**PROPOSED
HIGHWAY PLANS**

FAI 94 I-90/94 (DAN RYAN EXPRESSWAY)
AT 63rd STREET (FAU 1519)
SECTION 1920-B
PROJECT: ACNHPP-0005(990)
BRIDGE SUPERSTRUCTURE REPLACEMENT
SN 016-1149
COOK COUNTY
C-91-190-10

CONTRACT NO. 60J15

DAN RYAN MOT - STAGE A FOR WORK ON WEST ABUTMENT, PIER 2 AND PIER 4

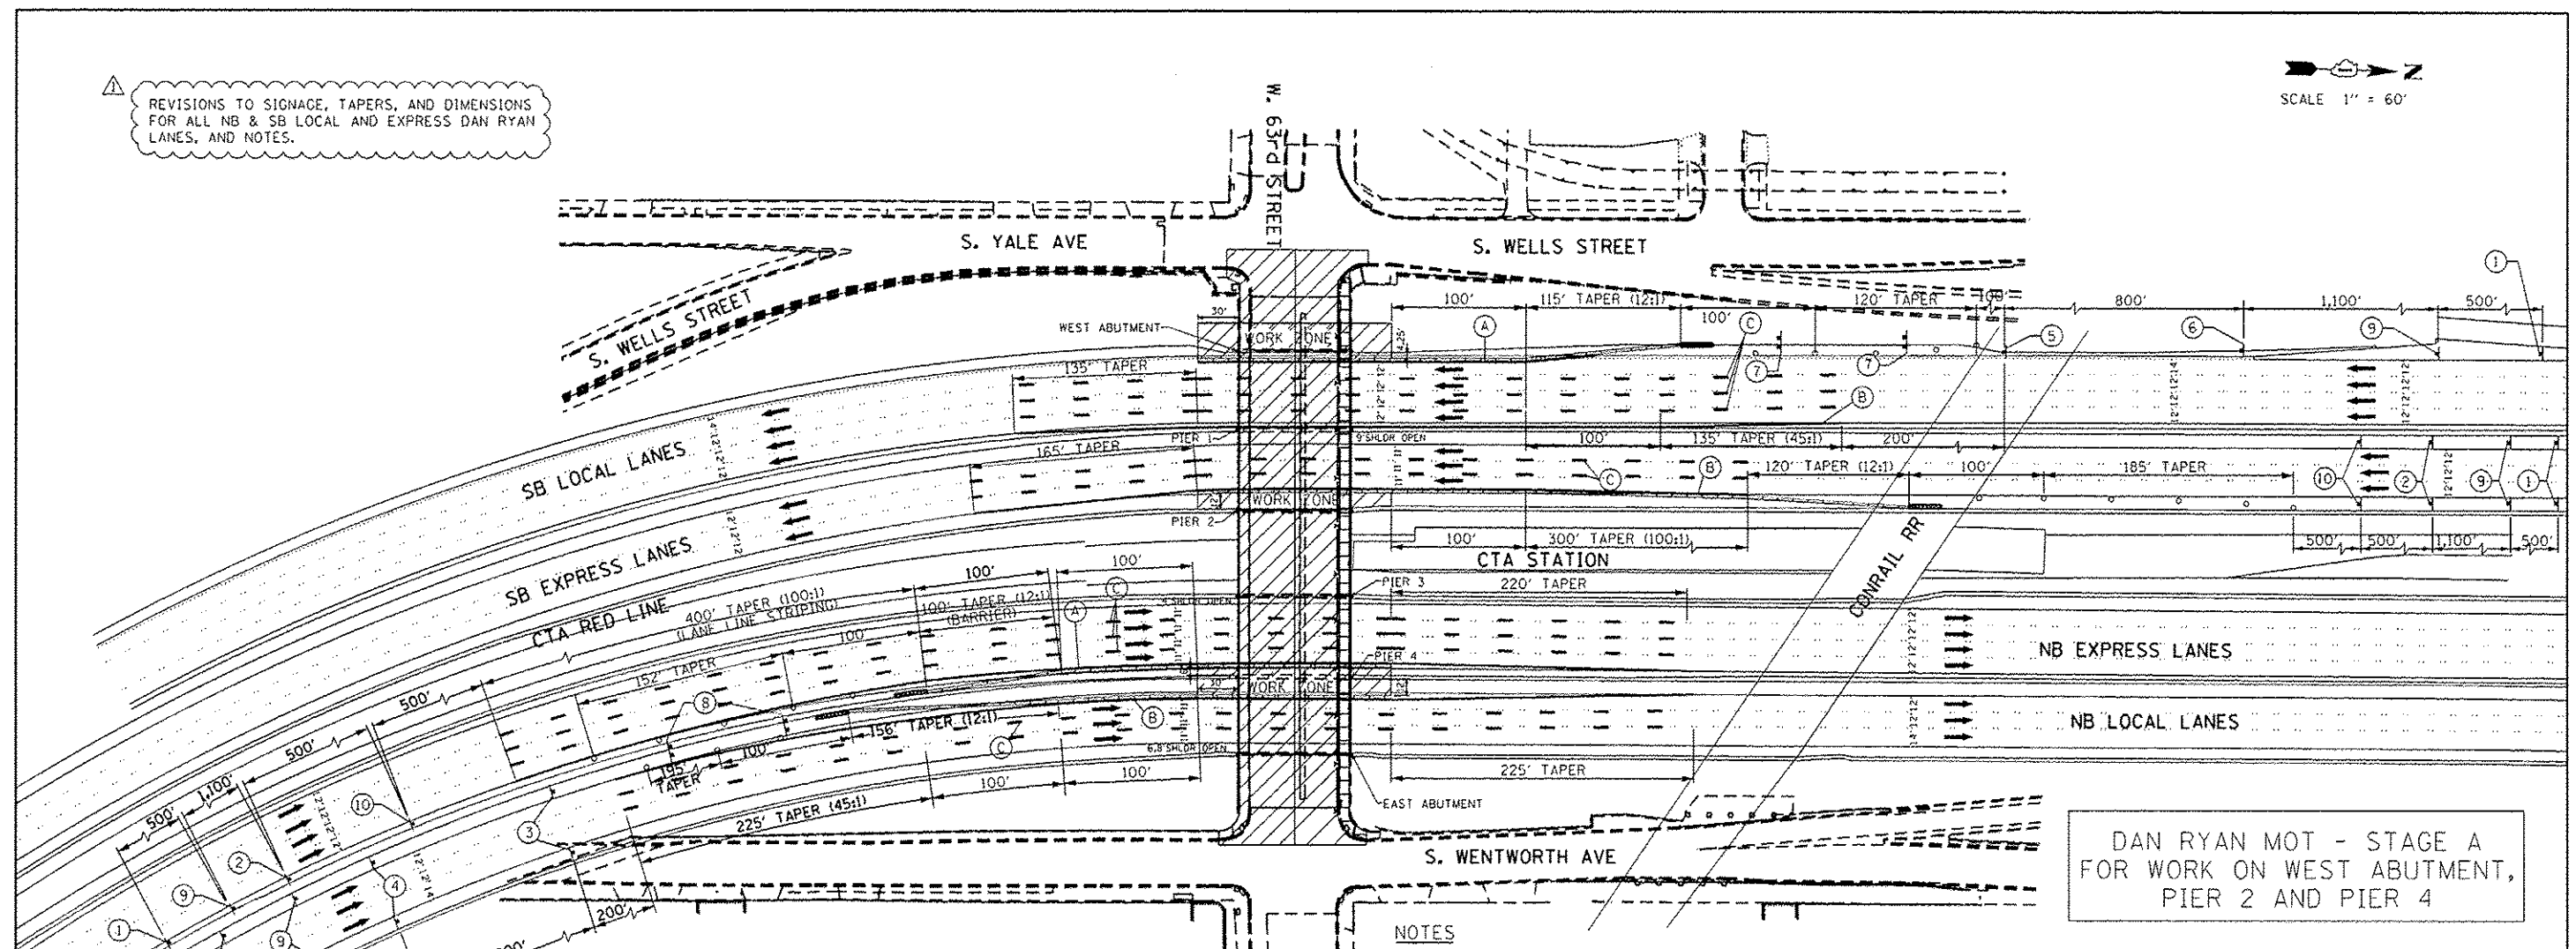
REVISIONS TO SIGNAGE, TAPERS, AND DIMENSIONS FOR ALL NB & SB LOCAL AND EXPRESS DAN RYAN LANES, AND NOTES.

DAN RYAN MOT - STAGE B FOR WORK ON PIER 1, PIER 3 AND EAST ABUTMENT

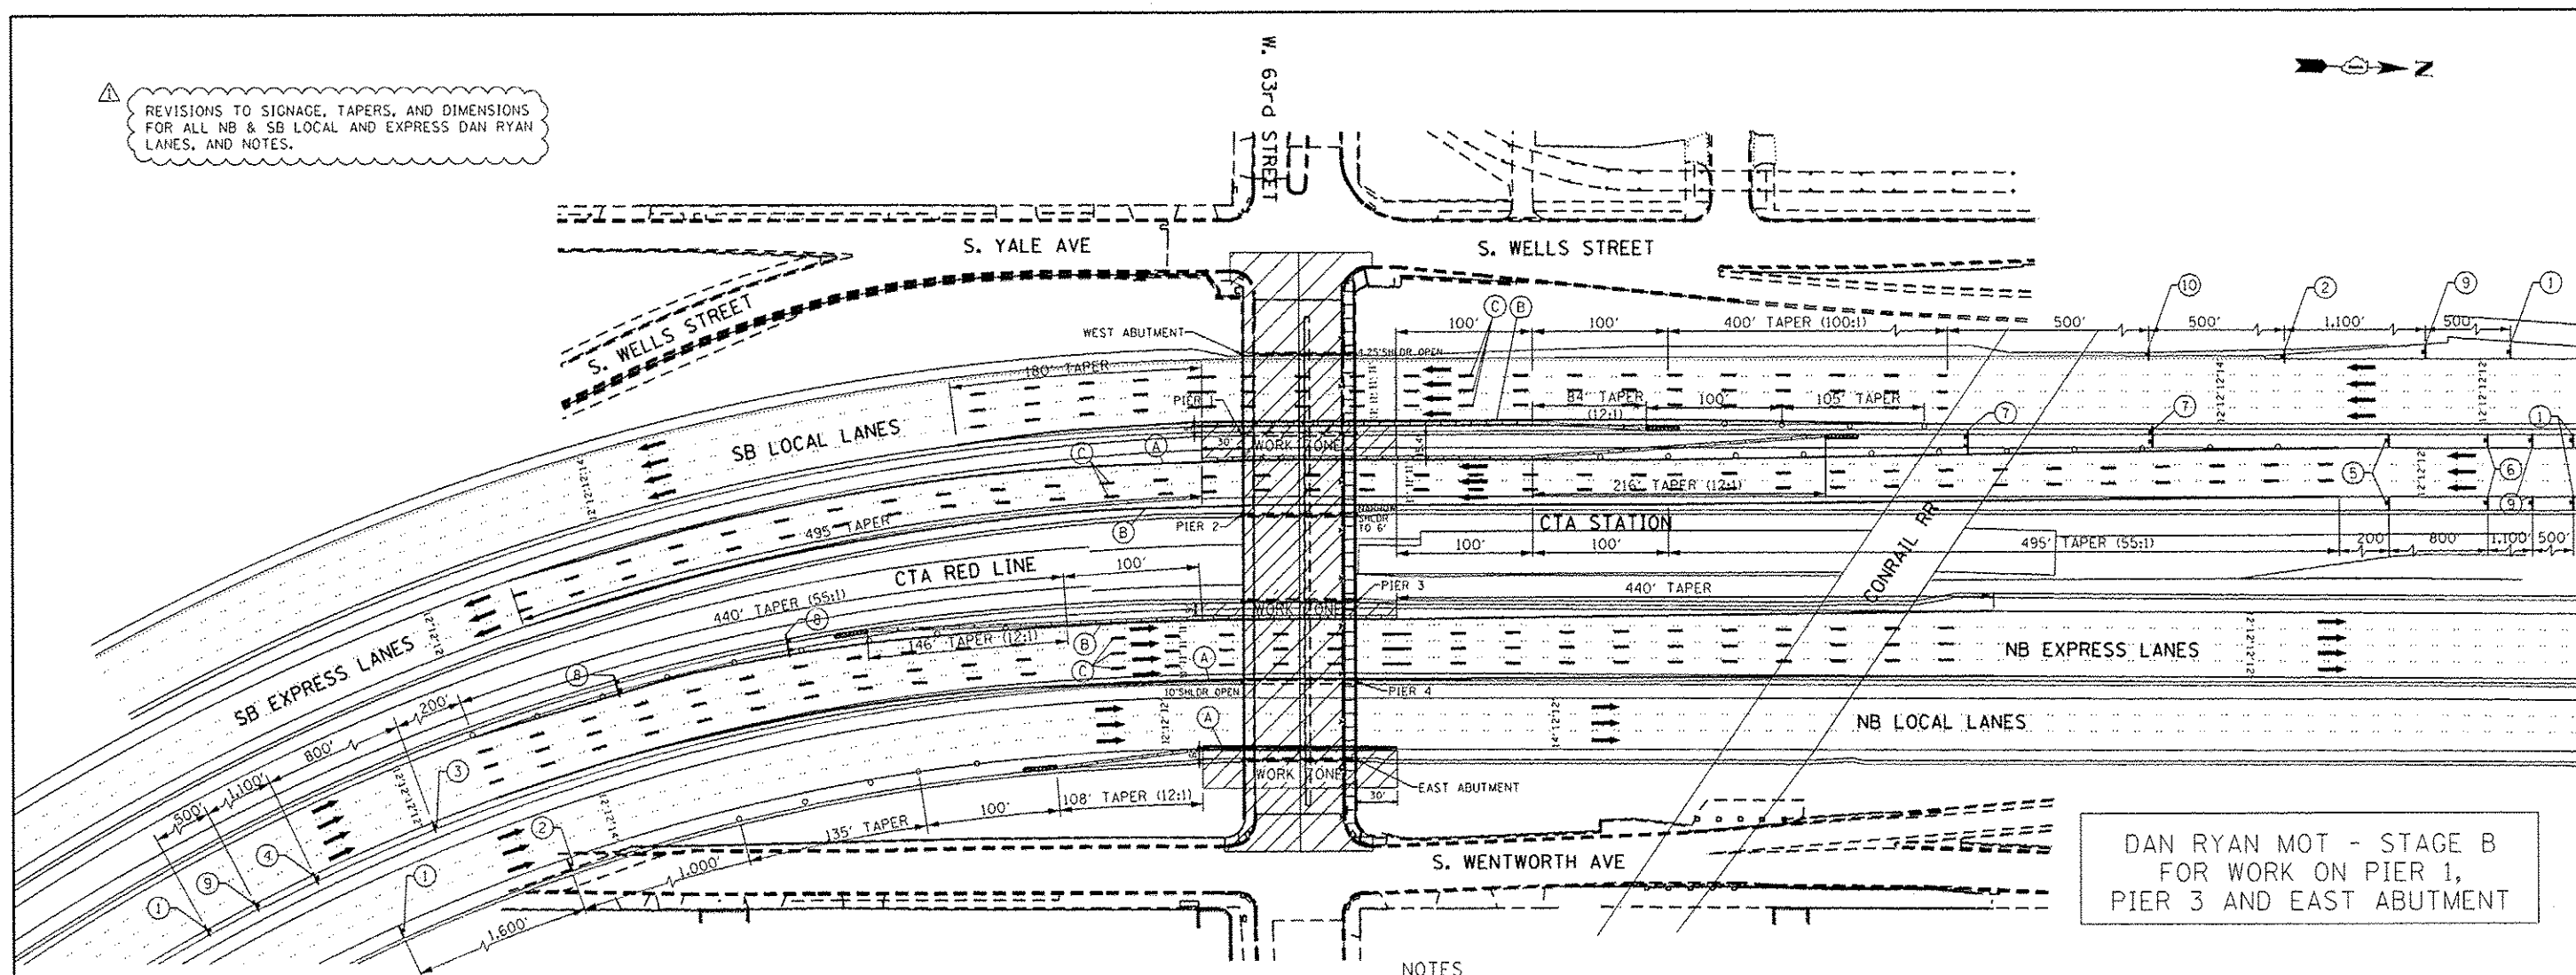
REVISIONS TO SIGNAGE, TAPERS, AND DIMENSIONS FOR ALL NB & SB LOCAL AND EXPRESS DAN RYAN LANES, AND NOTES.
